## West Buckinghamshire Area Planning Committee agenda

Date: Wednesday 12 April 2023

## Report to West Area Planning Committee

<b>Application Number:</b>	21/07006/REM
<b>Proposal:</b>	Reserved matters application for approval of access, appearance, landscaping, layout, scale and associated works including proposed Village Green scheme pursuant to outline planning permission 18/05597/OUT
<b>Site Location:</b>	Slate Meadow Stratford Drive Wooburn Green Buckinghamshire
<b>Applicant:</b>	Croudace Homes
<b>Case Officer:</b>	Declan Cleary
<b>Ward(s) affected:</b>	The Wooburns, Bourne End, and Hedsor
<b>Parish-Town Council:</b>	Wooburn and Bourne End
<b>Date valid application received:</b>	08/07/2021
<b>Statutory determination date:</b>	07/10/2021
<b>Recommendation</b>	Permit subject to a legal agreement (the agreement is already signed) and subject to planning conditions

Plan 1

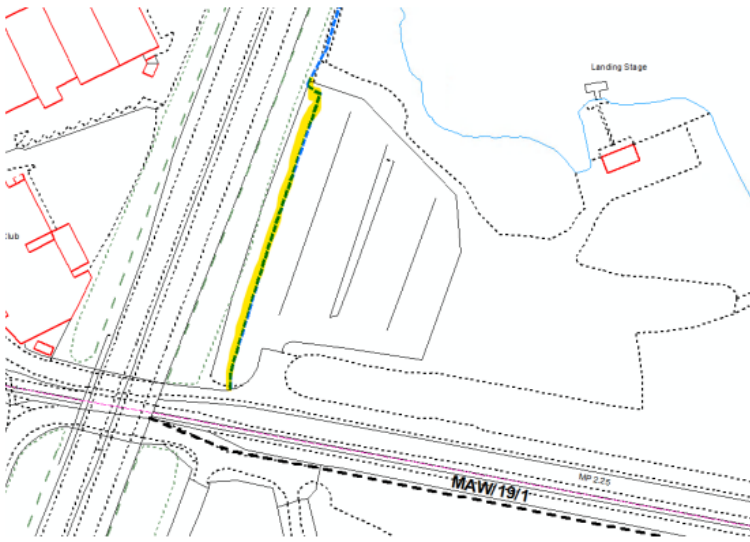
No. 1 - Regarding the definitive map modification order [DMMO] application, received by the council 15th November 2021, this was updated on 15th July 2022 to include the missing link to the adopted part of Fieldhouse Lane, but not shown in my earlier comments. The draft route annotation has now been updated through the car park and I have highlighted this yellow on Plans 1 & 2.

Due to the remaining uncertainty, and considering the claimed route now passes within the red edge, an informative is recommended. This uncertainty could be overcome by the applicant dedicating a bridleway along the claimed route, on land within their control, under s25 Highways Act 1980.

Plan 3

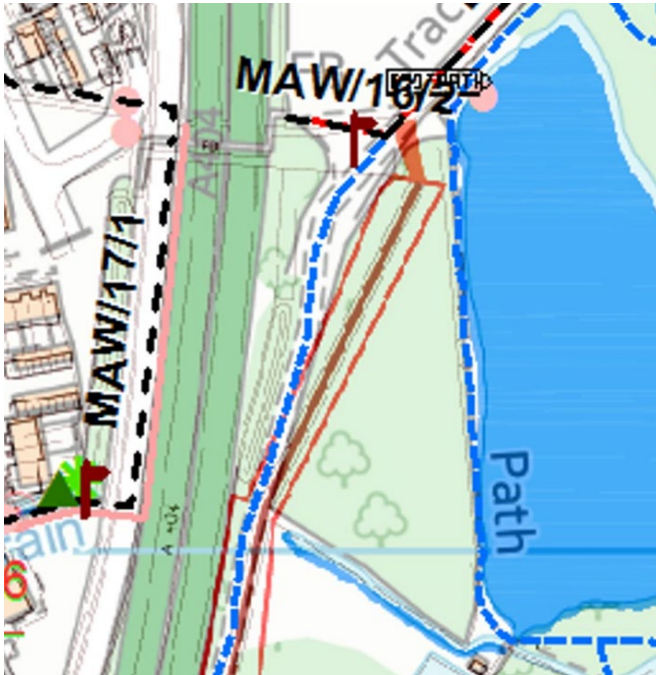
No. 2 - my attention has also been drawn to the proposed route near the Volvo Footbridge. While not having been on site, but having looked in greater detail, it appears the route proposed passes through some mature trees, rather than along the alignment currently being walked. I have enclosed an overlay of the claimed route [blue - to the west] and the route proposed in the application [brown - to the east] – see Plan 3. I have also enclosed an aerial photo to indicate the worn routes in this area [Plan 4].

Plan 1

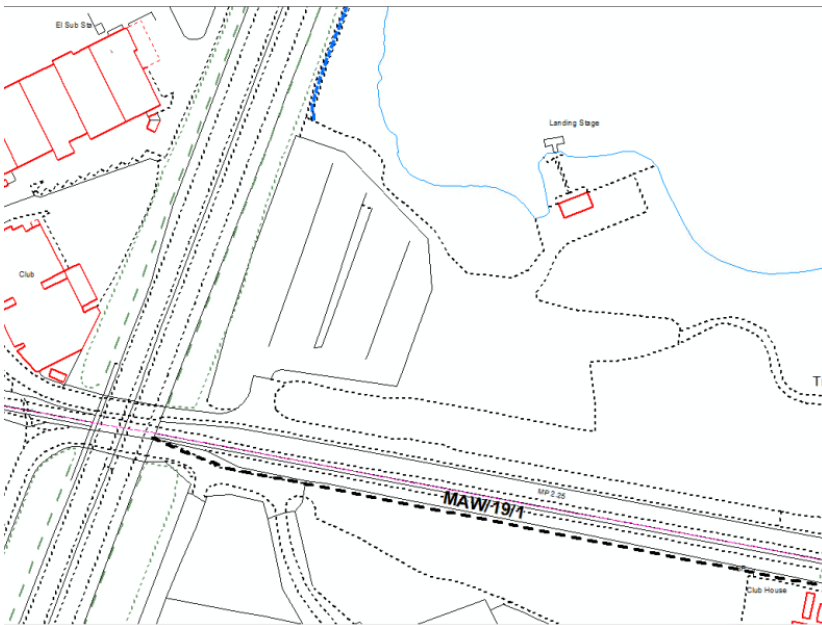
The red-dashed line along LMA/20/1 on Plan 1, sitting against the black-dashed line, indicates the council is in receipt of a definitive map modification order under Section 53 Wildlife & Countryside Act 1981 to record a public bridleway along the existing footpath alignment. This claim continues to Little Marlow and has not yet being investigated.

The blue-dashed lines on Plan 1 indicates the council is in receipt of a definitive map modification order under Section 53 Wildlife & Countryside Act 1981 to record public footpaths along alignments where no rights of way currently exist. You'll note the claimed path, running parallel with the A404, falls short of the publicly maintained highway along Fieldhouse Road and doesn't pass through the proposed car park – see Plan 2. The application confirms this path is unavailable as a through-route. The claim has not yet being investigated.

Extract 3 from Drawing 2738 PL 200

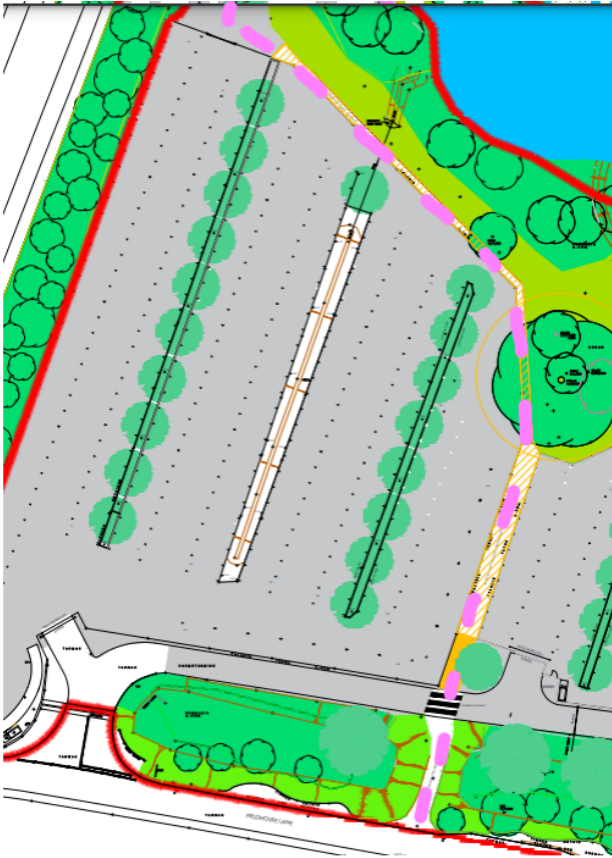
A Car Park Layout Drawing is provided indicating a walking and cycling route from Fieldhouse Way to a point north of the car park. I've annotated this with pink-dashed lines in Extract 3.

Two surfaces are proposed: a short section [orange] is marked 'bound surface' and the remainder [hatched orange] annotated as 'bound recycled wearing course'.

The first stretch north of the access road is 3m wide between paladin fences with a 3m wide surface. Once the route leaves the car park the surfacing reduces to 1m, but appears to be unfenced on the northern side.

Plan 3

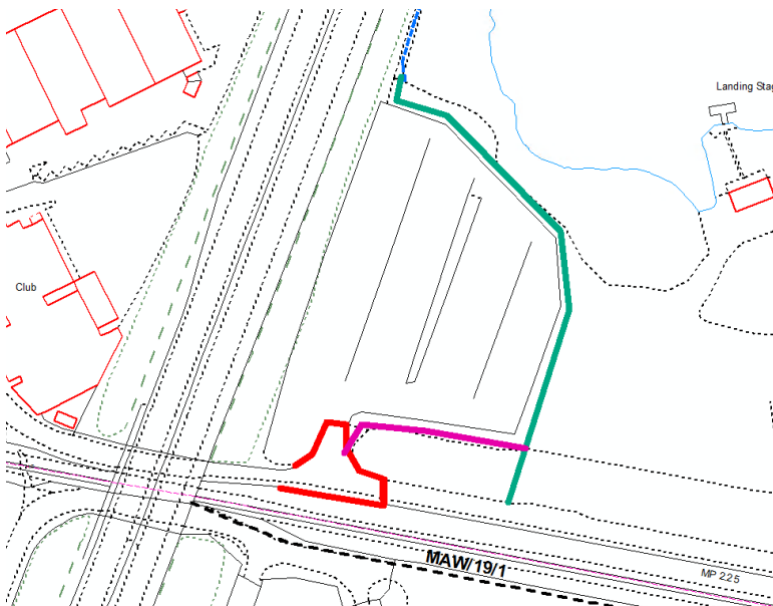
I have annotated the proposed walking and cycling route green on the OS base plan; and marked the publicly maintained vehicular highway in bold red.

The first issue is that the proposed walking and cycling route emerges onto a privately maintained part of Fieldhouse Road outside the red edge. It is important the route connects to the publicly maintained part of Fieldhouse Road to avoid 3rd party ownership. I've annotated a suggestion in pink that could resolve this issue.

The risk with emerging onto 3rd party land is that the route could be gated or otherwise rendered inaccessible unless bridleway rights are extended to the adopted part of Fieldhouse Road. An alternative resolution is to gain 3rd party permission [from the owner of Fieldhouse Lane] to dedicate a bridleway along the currently unadopted section, thus making the connection from green to red in my sketch [Plan 3]. A written undertaking and/or extension of the red edge would be required.

Plan 4

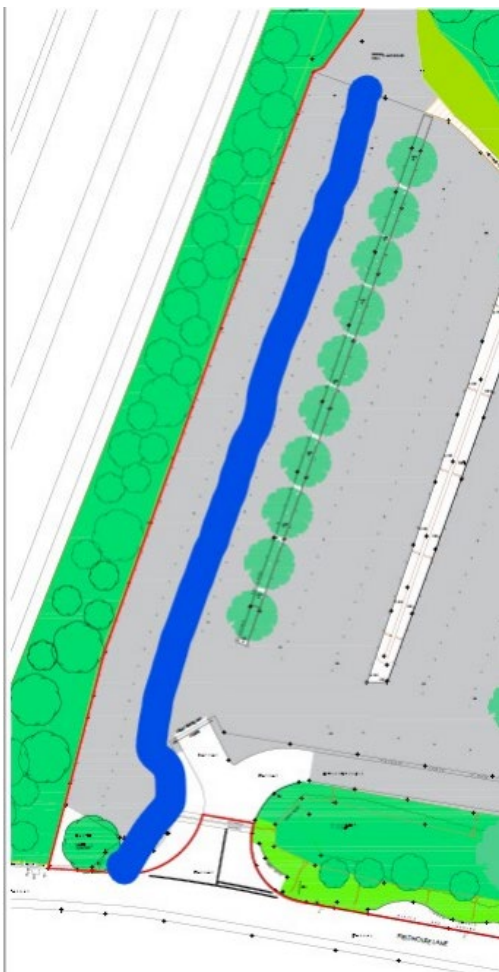
Notwithstanding the pink annotation above, my preference would be to accommodate a shorter desire line route, directly north to south through the car park from the vicinity of the existing pedestrian entrance onto Fieldhouse Road [bold blue in plan 4]. Alternatively, if security precludes this option, some thought could be given to a similarly direct corridor north to south, bounded on the west side by National Highways ownership at the foot of the A404 embankment, which closely aligns with the Film Studios suggested route as shown above [Extract 1]. This allows for the segregation of uses [private car park vs public bridleway] which appears important for site security.

As mentioned above, the 3m wide surfacing reduces to 1m on the north side. With the route being shared between pedestrians and cyclists 3m is the minimum standard. I would also recommended a bitumen surface throughout the vicinity of the car park, as the highway authority would ultimately inherit maintenance responsibility and insurance liability. An example specification is provided

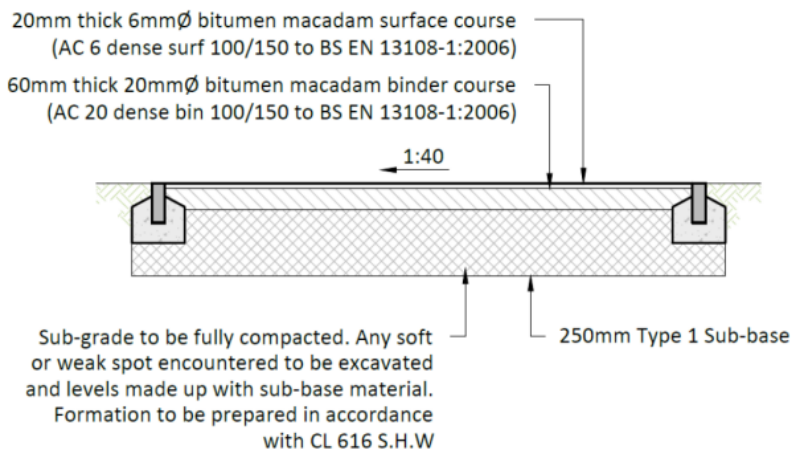
below [where a 200mm sub-base would be sufficient with concrete edging]. If a recycled or low carbon material is preferred, I would recommend KBI Flexipave [a rubber crumb material made from recycled tyres] above a similar depth of sub\_base.

With regard to the surface specification, there isn't enough detail in the application for me to be confident an appropriate surface will be provided. However, this matter could be covered by a condition
